SOUTH CAROLINA BUILDING CODES COUNCIL  
2021 INTERNATIONAL RESIDENTIAL CODE  
MEETING MATERIALS  
OCTOBER 6, 2021

**2021 International Residential Code**  
**South Carolina Building Codes Council**  
**Modification Continuations from 2018**

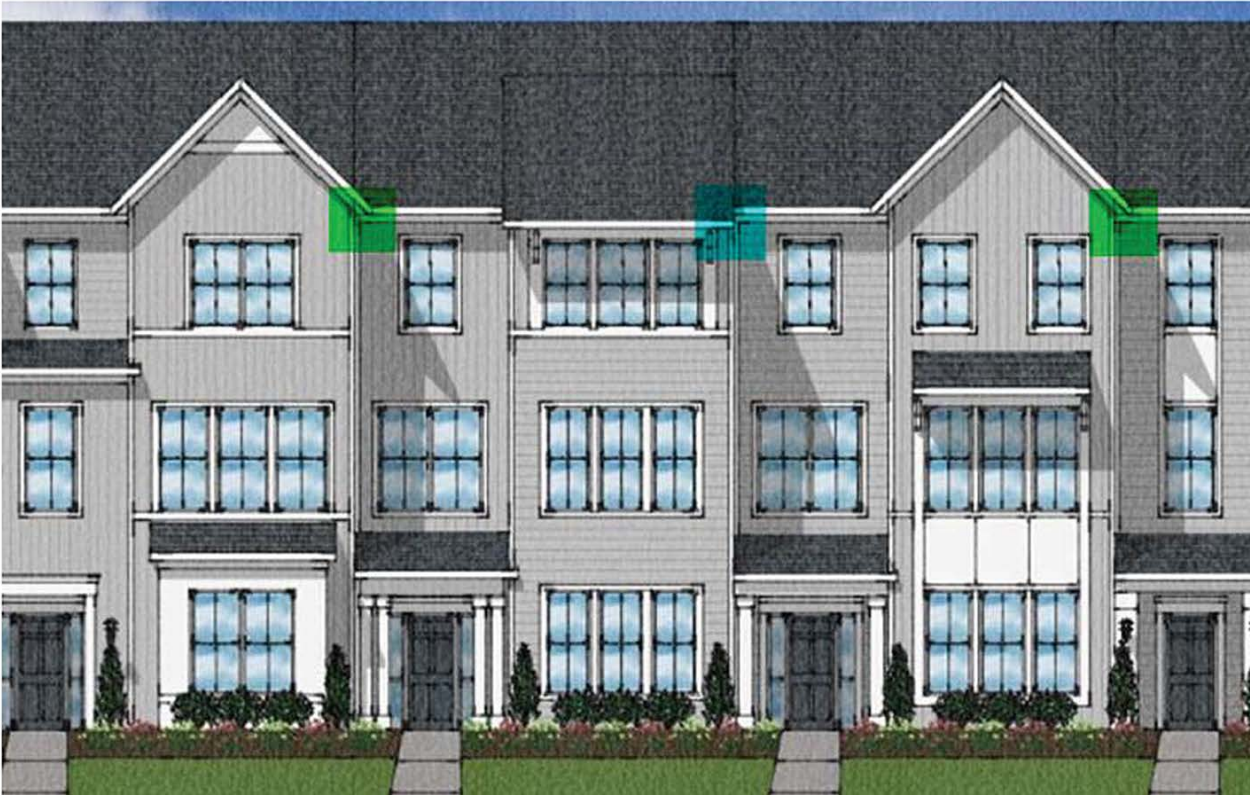
Justification: This modification would provide flexibility and reduce the current restriction to architectural design when the design calls for fluid transition visually between townhome units. The 12" eave projection limit requested represents a minimal convergence on the adjacent unit.

As illustrated below the green highlights represent sample overhangs that would be allowed per this modification. Blue highlights have no eave projections to the adjacent property.

**FIGURE R307.1**  
**MINIMUM FIXTURE CLEARANCES**

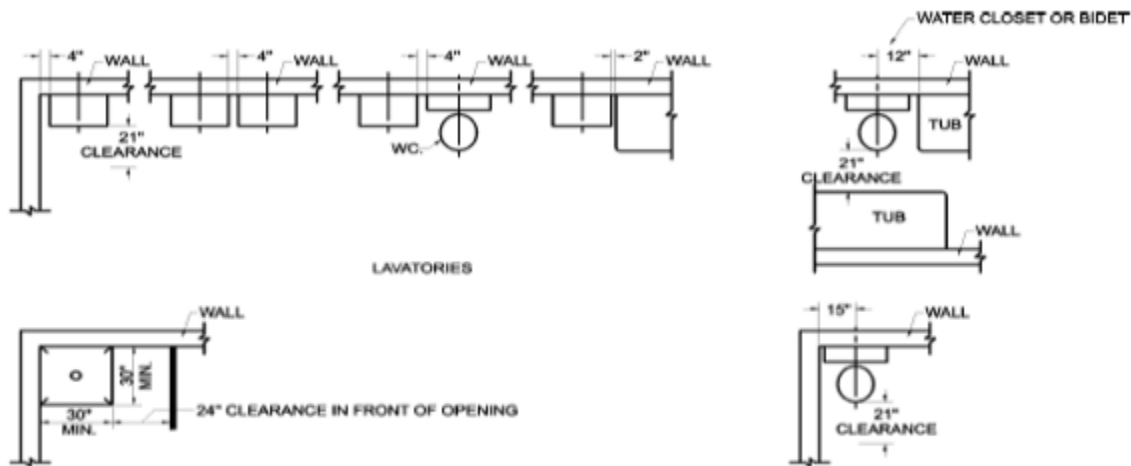
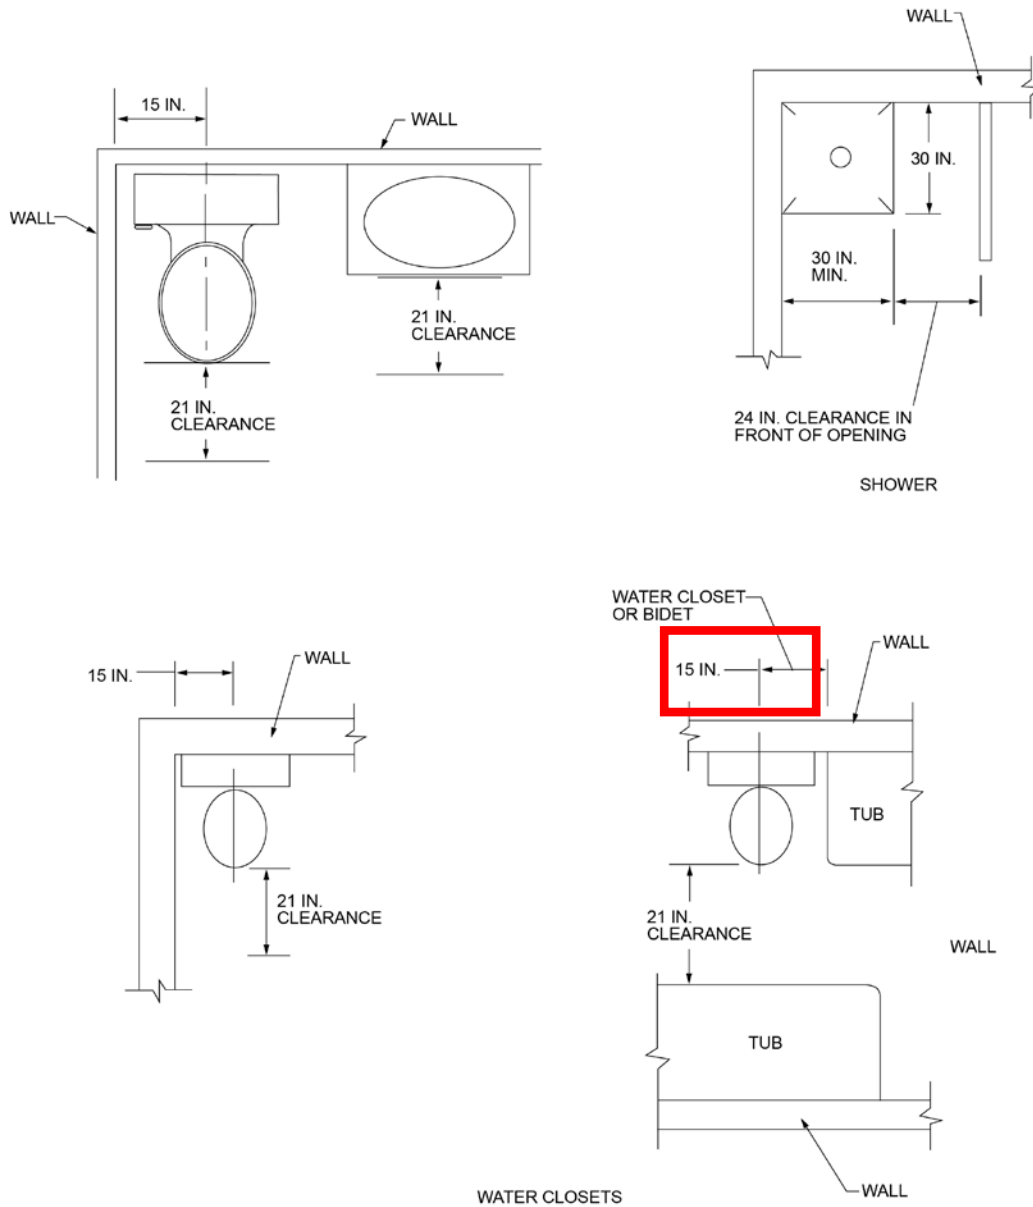
**Modification:** Change the minimum dimension for the side clearance between bathtubs and water closets and bidets from 15 inches to 12 inches.

**Reason:** No valid reason exists to justify a minimum clearance of 15 inches

**Comments:** See clerical correction above. Also, this is a very old chart. Newer chart should be easier to use and just change 15 inches to 12 inches. Figure is also 307.1, not 307.2

7/27 Study Committee Recommendation: Support approval with use of updated drawing (next page) with adding part in red to 12 inches. Clerical error noted above about "Figure" also approved.
